SECTION 96 MODIFICATION TO DA269/2015:

NORTHERN BEACHES COUNCIL
 THIS PLAN IS TO BE READ IN CONJUNCTION WITH
 Endorsement Date: 20/06/2018
 Mod2018/0180

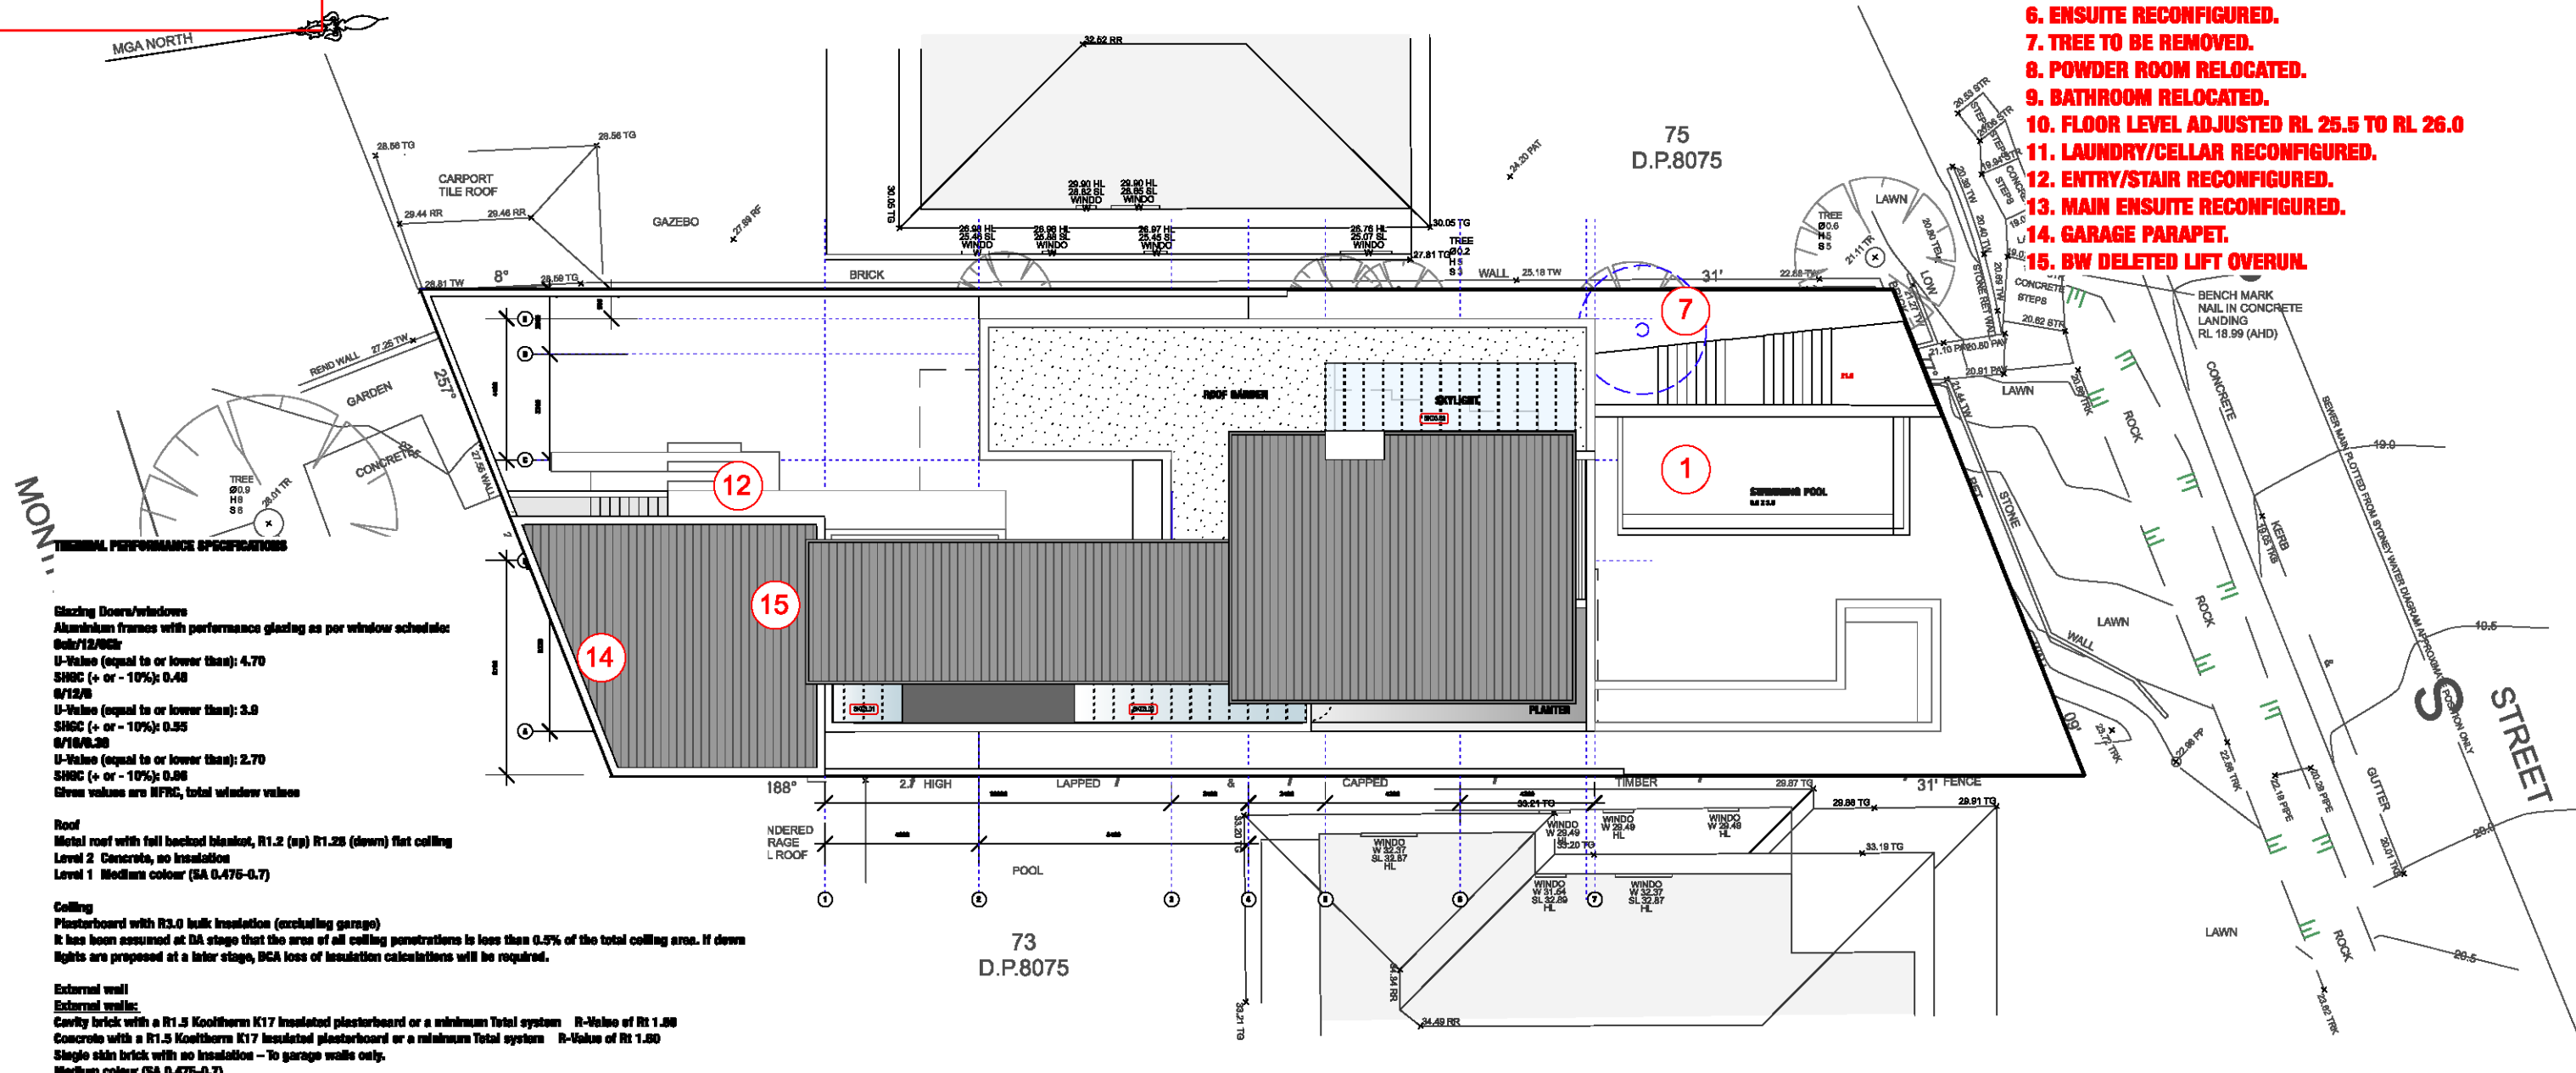
1. SWIMMING POOL ADJUSTED.
2. INTERNAL STAIR RECONFIGURED.
3. SERVICE AREA RECONFIGURED.
4. GYM RECONFIGURED.
5. LIGHTWELL/VOID.
6. ENSUITE RECONFIGURED.
7. TREE TO BE REMOVED.
8. POWDER ROOM RELOCATED.
9. BATHROOM RELOCATED.
10. FLOOR LEVEL ADJUSTED RL 25.5 TO RL 26.0
11. LAUNDRY/CELLAR RECONFIGURED.
12. ENTRY/STAIR RECONFIGURED.
13. MAIN ENSUITE RECONFIGURED.
14. GARAGE PARAPET.
15. BW DELETED LIFT OVERUN

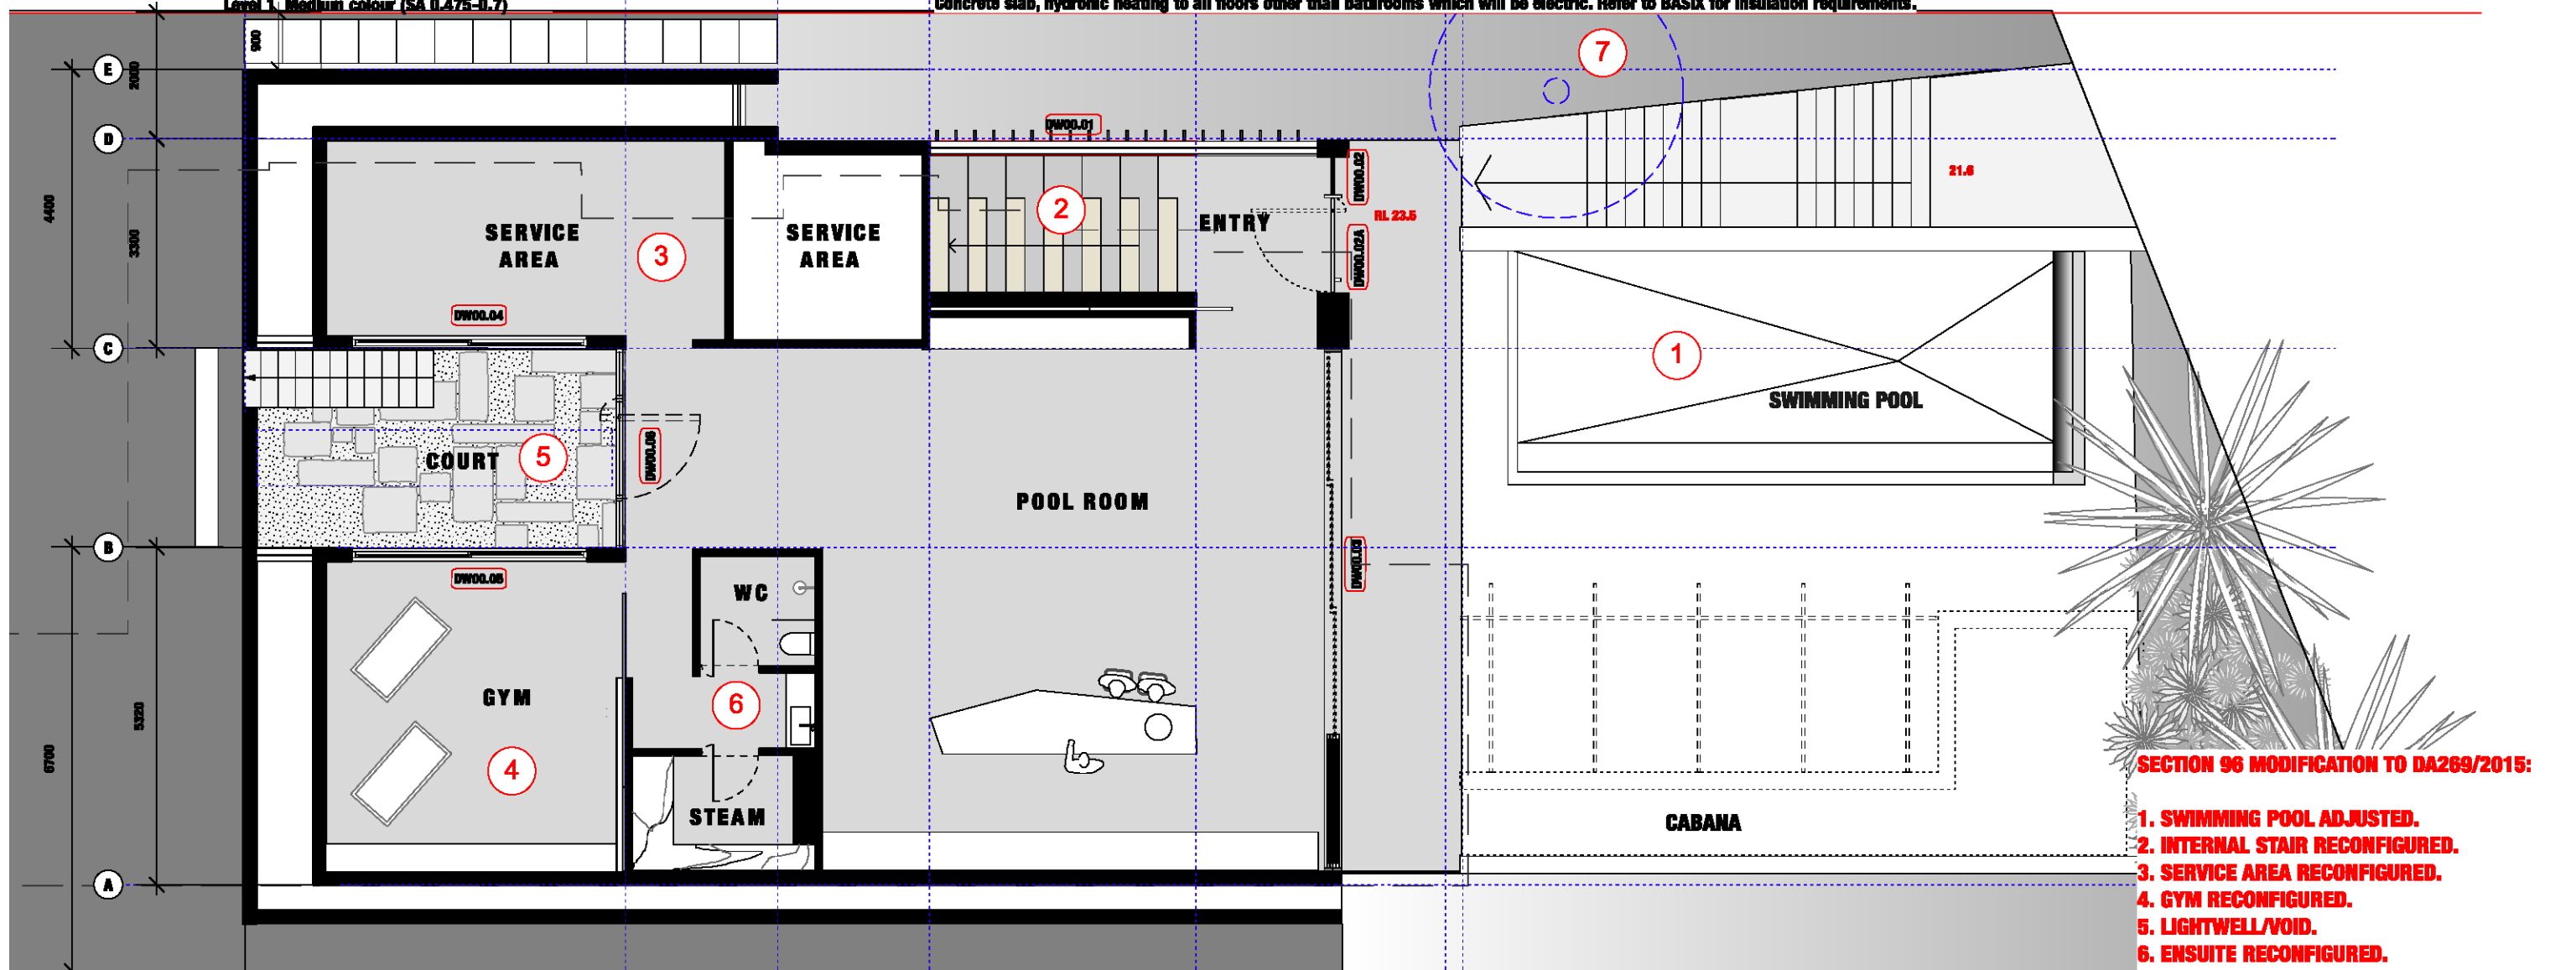
1. SWIMMING POOL ADJUSTED.
2. INTERNAL STAIR RECONFIGURED.
3. SERVICE AREA RECONFIGURED.
4. GYM RECONFIGURED.
5. LIGHTWELL/VOID.
6. ENSUITE RECONFIGURED.
7. TREE TO BE REMOVED.
8. POWDER ROOM RELOCATED.
9. BATHROOM RELOCATED.
10. FLOOR LEVEL ADJUSTED RL 25.5 TO RL 26.0
11. LAUNDRY/CELLAR RECONFIGURED.
12. ENTRY/STAIR RECONFIGURED.
13. MAIN ENSUITE RECONFIGURED.
14. GARAGE PARAPET.
15. BW DELETED LIFT OVERUN.

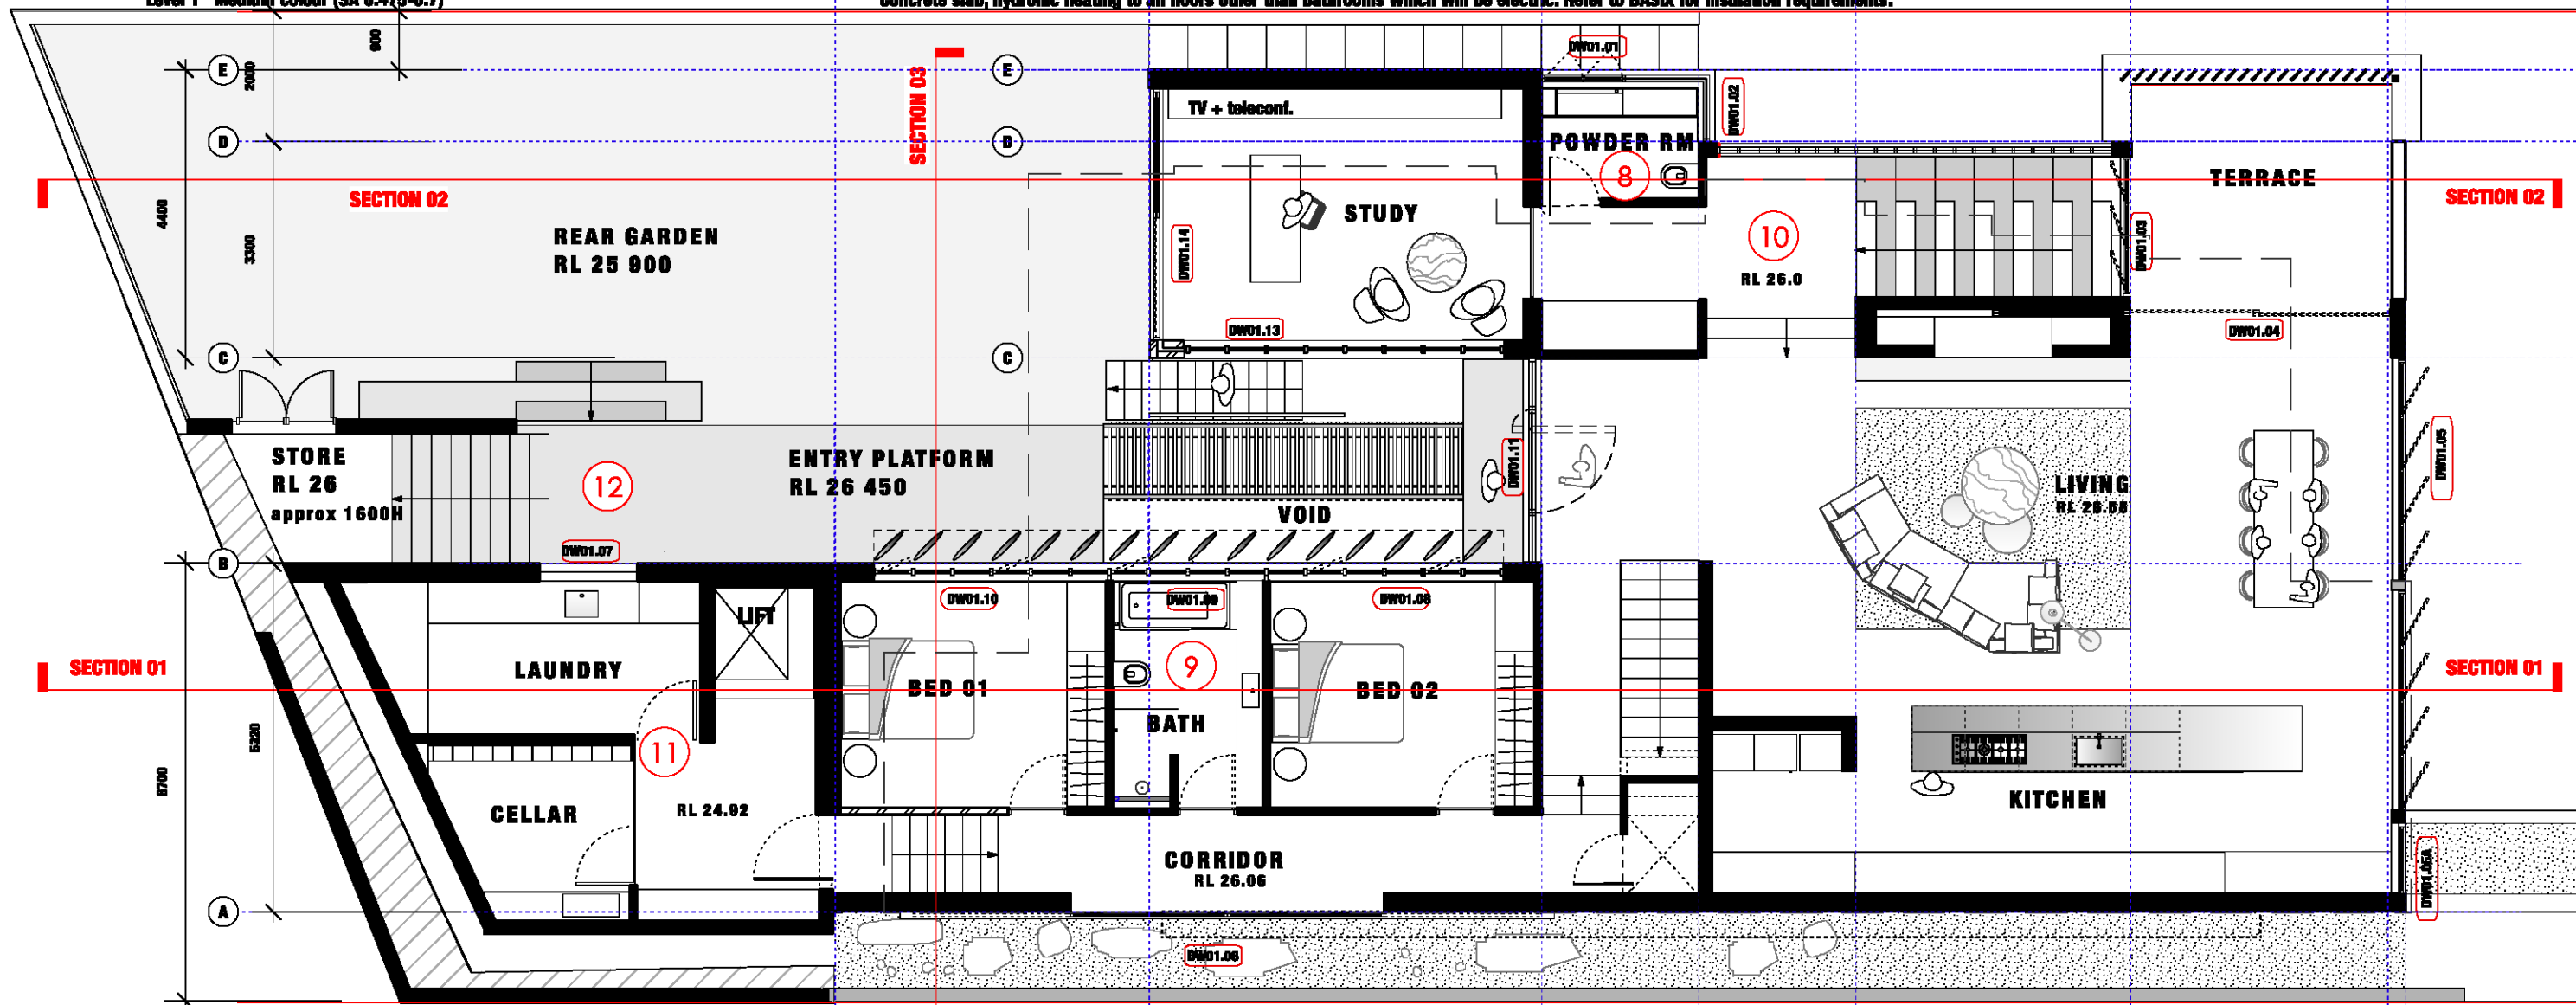
1. SWIMMING POOL ADJUSTED.
2. INTERNAL STAIR RECONFIGURED.
3. SERVICE AREA RECONFIGURED.
4. GYM RECONFIGURED.
5. LIGHTWELL/VOID.
6. ENSUITE RECONFIGURED.
7. TREE TO BE REMOVED.
8. POWDER ROOM RELOCATED.
9. BATHROOM RELOCATED.
10. FLOOR LEVEL ADJUSTED RL 25.5 TO RL 26.0
11. LAUNDRY/CELLAR RECONFIGURED.
12. ENTRY/STAIR RECONFIGURED.
13. MAIN ENSUITE RECONFIGURED.
14. GARAGE PARAPET.
15. BW DELETED LIFT OVERUN.

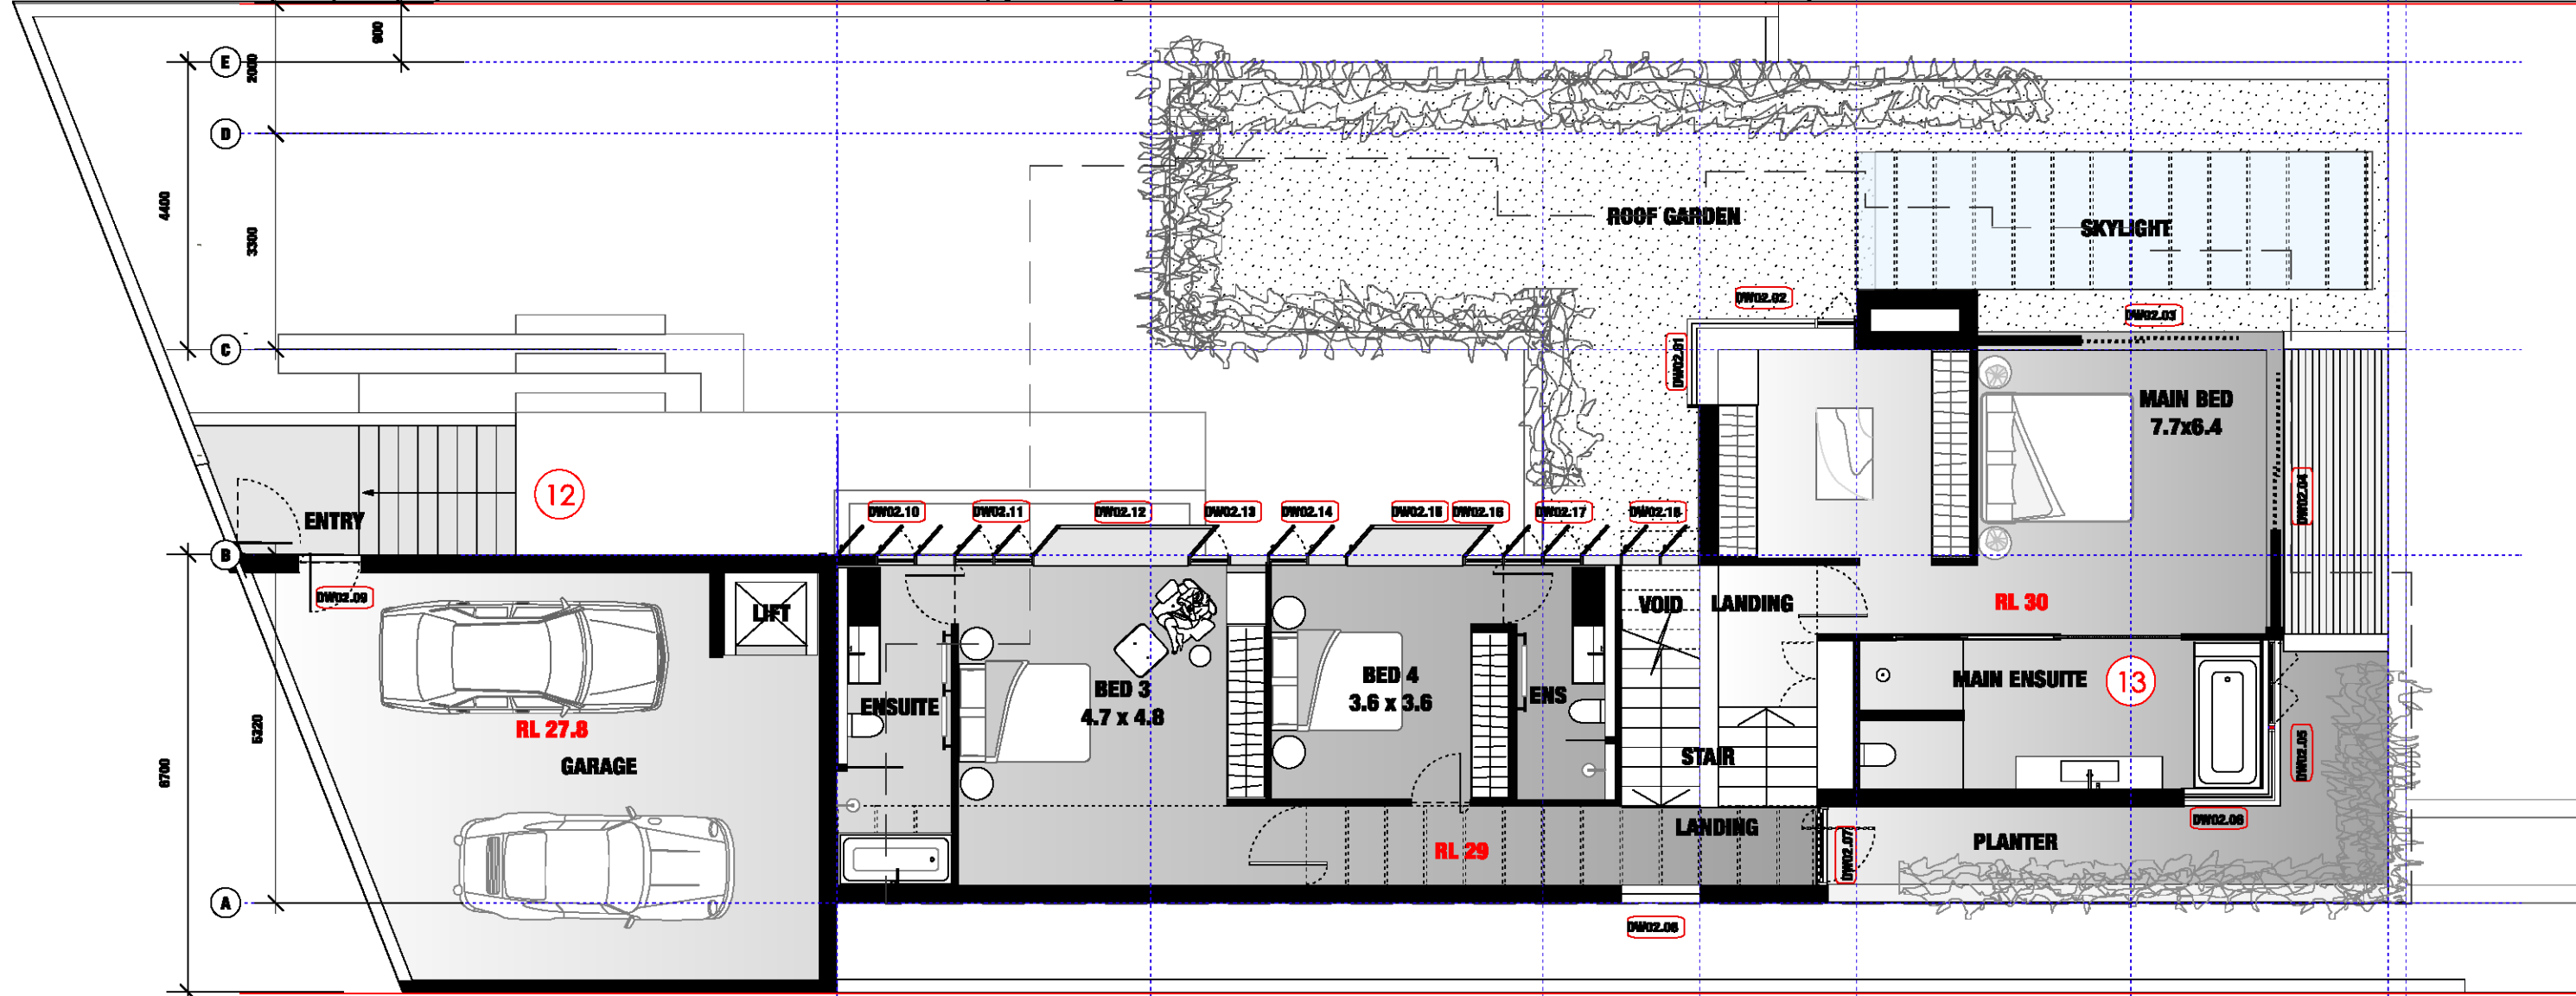
1. SWIMMING POOL ADJUSTED.
2. INTERNAL STAIR RECONFIGURED.
3. SERVICE AREA RECONFIGURED.
4. GYM RECONFIGURED.
5. LIGHTWELL/VOID.
6. ENSUITE RECONFIGURED.
7. TREE TO BE REMOVED.
8. POWDER ROOM RELOCATED.
9. BATHROOM RELOCATED.
10. FLOOR LEVEL ADJUSTED RL 25.5 TO RL 26.0
11. LAUNDRY/CELLAR RECONFIGURED.
12. ENTRY/STAIR RECONFIGURED.
13. MAIN ENSUITE RECONFIGURED.
14. GARAGE PARAPET.
15. BW DELETED LIFT OVERUN.
